**Suggestion for changes to ECE/TRANS/WP.29/GRSG/2018/17, proposed
amendments to UN Regulation No. 26 (External projection for passenger cars)
submitted by France**

Figure 0 – Example of parts distribution"

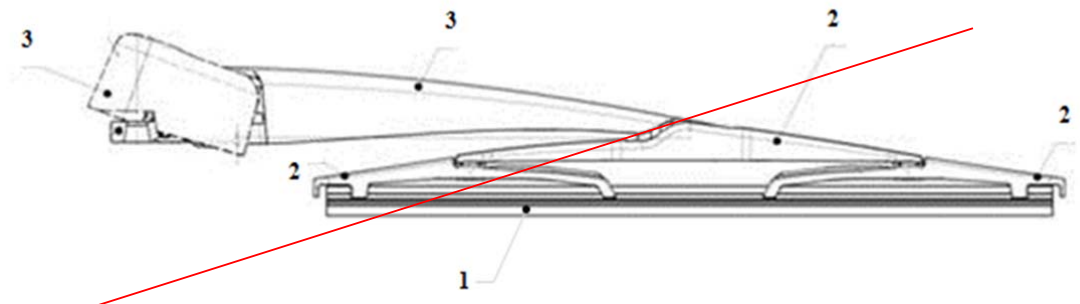
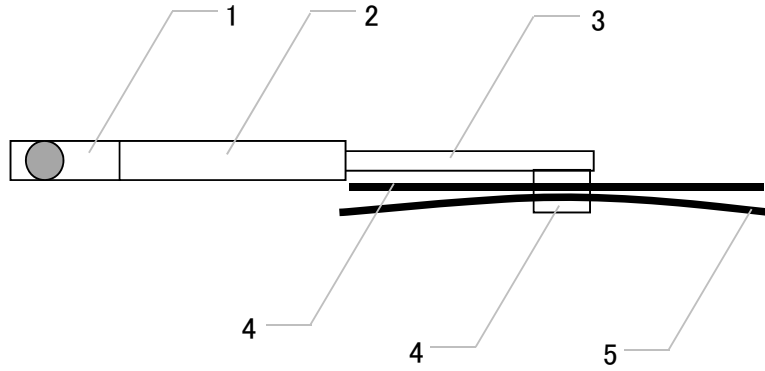
- 6.4.1. The windscreen wiper fittings shall be such that the wiper shaft **and the wiper holder (numbers 1, 2 [and 3] on figure 0) is are designed or** furnished with a protective casing **which has with** a radius of curvature meeting the requirements of paragraph 5.4. above and an end surface area of not less than 150 mm². In the case of rounded covers, these shall have a minimum projected area of 150 mm² when measured not more than 6.5 mm from the point projecting furthest. These requirements shall also be met by rear window wipers and headlamp wipers.
- 6.4.2. Paragraph 5.4. shall not apply to the wiper blades (**number 1 5 on figure 0**) or to any supporting members (**numbers 2 4 on figure 0**). However, these units shall be so made as to have no sharp angles or pointed or cutting parts.

In order to avoid any misunderstanding on which requirement apply to which part of the windscreen wiper, a simple generic drawing presenting the concerned areas seems to be the best way for a safe application. Geometrical requirements are only applicable on contactable parts (sphere protocol).
